Hawker Series

All Hawker 125 Series Aircraft

**Communiqué # HK-0038
November, 2011**

ATA 26 - Fire Protection - Electrical Wire Protection Kit

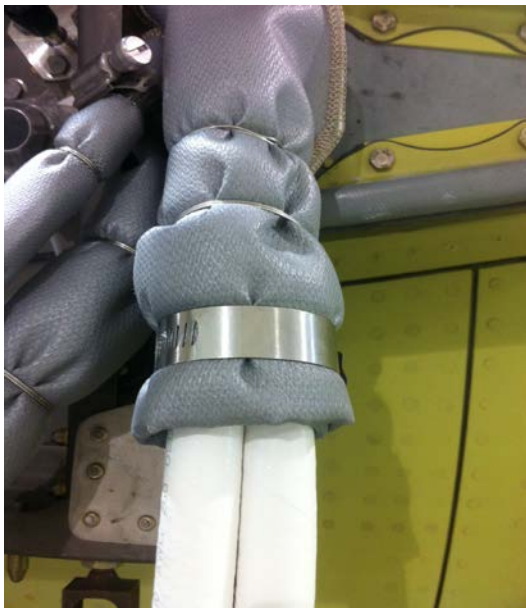
Hawker Beechcraft Corporation (HBC) is issuing this Model Communiqué to inform owners, operators, and service centers of a chafing condition that could exist between the fairlead wire cover blankets mounting hardware and the engine inlet assemblies.

The clamps that mount the fairlead wire cover blankets may be disturbed during routine maintenance in the area. Sometimes, the tails of the clamp are pulled away from the body, resulting in the flared tail coming into contact with the engine inlet assembly. Continued contact may result in chafing to the inlet assembly. HBC recommends that extra care be taken to ensure the clamp tails are secured against the clamp body to avoid potential contact with the engine inlet assembly.
